## **REGATTA VITA SUBDIVISION**

***Revised for the January 20, 2011, meeting.***

APPLICATION NUMBER 1 DATE January 20, 2011

REQUEST Subdivision

## DETAIL SITE PLAN

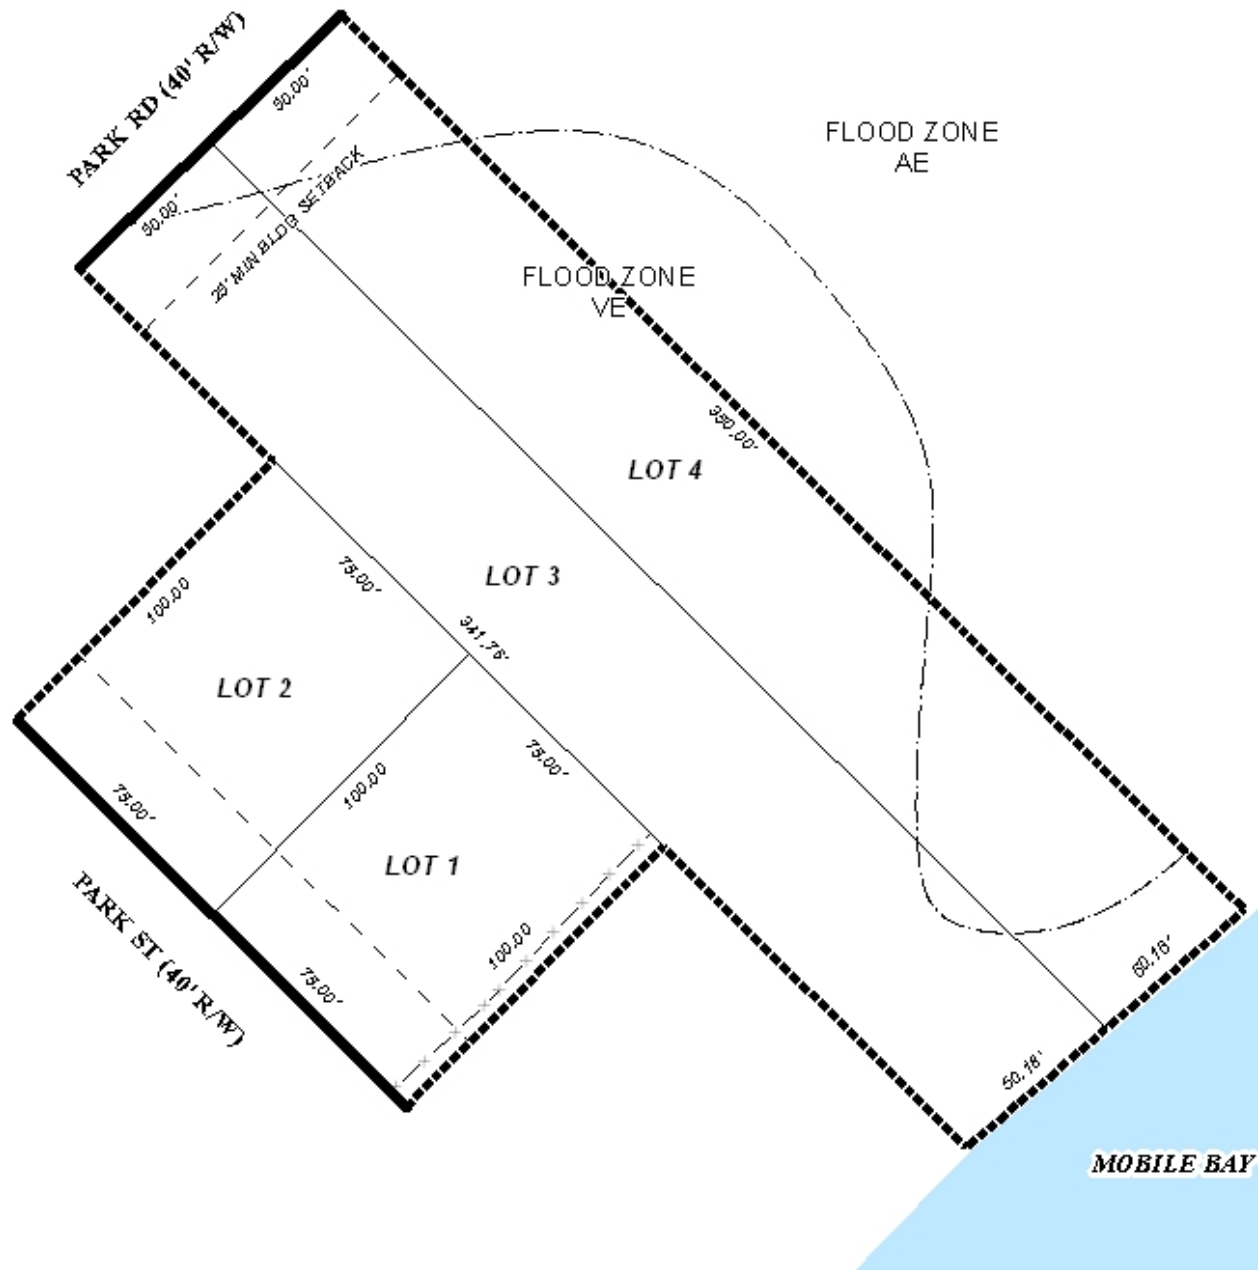
Engineering Comments: Show Minimum Finished Floor Elevation (FFE) on each lot on Plat. Need to verify location of AE/VE line scaling from FIRM maps (3-17-2010), there appears to be a minor discrepancy between line location on plat compared to FIRM map. Any proposed structure shall be constructed on pilings with the bottom of the lowest horizontal structural member to be placed above Minimum FFE. Add note to plat that there is to be absolutely no fill placed within the limits of the flood plain. Must comply with all storm water and flood control ordinances. Any work performed in the right of way will require a right of way permit.

The proposed lots 3 and 4, as depicted, do not meet the minimum frontage requirement as regulated by Section V.D.2. of the Subdivision Regulations, as the proposed lots are depicted with 50 feet of frontage; a minimum of 60 feet of frontage is required. Both of these proposed lots were originally platted with the same dimensions as proposed as Lots 26 and 27, Block 1, Alba Beach Subdivision. The re-platting is not necessary, and these lots could, in fact, be excluded from this application. However, if the applicant wishes for these lots to remain on the plat, a waiver as Section V.D.2. as it relates to the minimum frontage requirement may be appropriate. Both of the proposed lots meet the minimum lot size requirements of the Subdivision Regulations.

Regarding the proposed Lots 1 and 2, the lots, as depicted, meet the minimum size and frontage requirements as regulated by the Subdivision Regulations. However, the proposed lots have frontage on a street with a substandard right-of-way. The proposed lots front Park Street, a minor street not provided with curb and gutter. Park Street is depicted as having a 40-foot wide right-of-way. Section V.B.14. of the Subdivision Regulations requires a minor street without curb and gutter to have a minimum right-of-way width of 60 feet. As such, dedication sufficient to provide 30 feet from the centerline will be required. This dedication would reduce the

As stated previously, the site has frontage on Park Road to the West and Park Street to the South. Both roadways are minor streets, not provided with curb and gutter, and both are depicted with an existing right-of-way of 40 feet. The Subdivision Regulations require minor streets without curb and gutter to have a minimum right-of-way of 60 feet; as such, dedication sufficient to provide 30 feet from the centerline should be required.

Given that proposed Lots 1 and 2 will fall below the required minimum lot size requirement and the site's situation regarding coastal flood hazard, the two new lots may be inappropriate.

- 1) with required dedications, Lots 1 and 2 will not meet the minimum size requirements; and
- 2) the substandard lots are located within a FEMA designated flood zone with coastal hazard, and thus the property may be proposed for overdevelopment.
